Access Compliance Report

Public Rights-of-Way

(Curb Ramps)

Intersection ID: N/A	Main Street: ARDREY_KELL_RD	Cross Street: WAVERLY_WALK_AV	Location: NE
ADA ID: 4805DF790A57	Ramp Type: Directional1	Initial Pass/Fail: Fail	Overall Compliance: No
Severity Score: 12.5			
Codes/Mitigation Info/Possible Solution		Field Measurements/Component Compliance

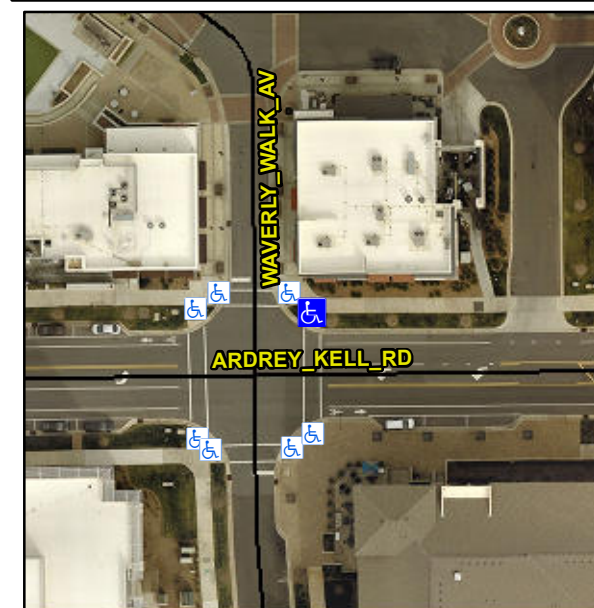
R304.5.3

Compliance	Description	Data	Compliance	Description	Data
N/A	Ramp Length (in)	98.0	N/A	Grade Break?	N/A
Yes	Ramp Width (in)	94.0	N/A	Grade Break Slope (%)	0.0
Yes	Ramp Slope (%)	5.3	N/A	Grade Break XSlope (%)	0.0
No	Ramp XSlope (%)	5.8			
N/A	Flare Type LT	N/A	N/A	Flare Type RT	N/A
N/A	Flare Slope LT (%)	N/A	N/A	Flare Slope RT (%)	0.0
N/A	Flare Traversable LT?	N/A	N/A	Flare Traversable RT?	N/A
N/A	Landing Length (in)	0.0	N/A	DWS Provided?	N/A
N/A	Landing Width (in)	0.0	N/A	DWS Contrast?	N/A
N/A	Landing Slope (%)	0.0	N/A	DWS Length (in)	N/A
N/A	Landing X Slope (%)	0.0	N/A	DWS Full Width?	N/A
N/A	Landing Curb? (Y/N)	N/A	N/A	DWS Offset LT (in)	N/A
N/A	Shared Landing?	N/A	N/A	DWS Offset RT (in)	N/A
N/A	Gutter Ponding?	0.0	N/A	Gutter Slope (%)	N/A
N/A	Gutter Lip Ht (in)	0.0	N/A	Gutter X Slope (%)	N/A
N/A	Painted X Walk1?	Yes		Road Slope (%)	1.3
	X Walk 1 Direction	To S		Road X Slope (%)	0.5
	X Walk 1 Width (in)	109.0		Clear Space?	N/A

Remove & Replace Entire Ramp.
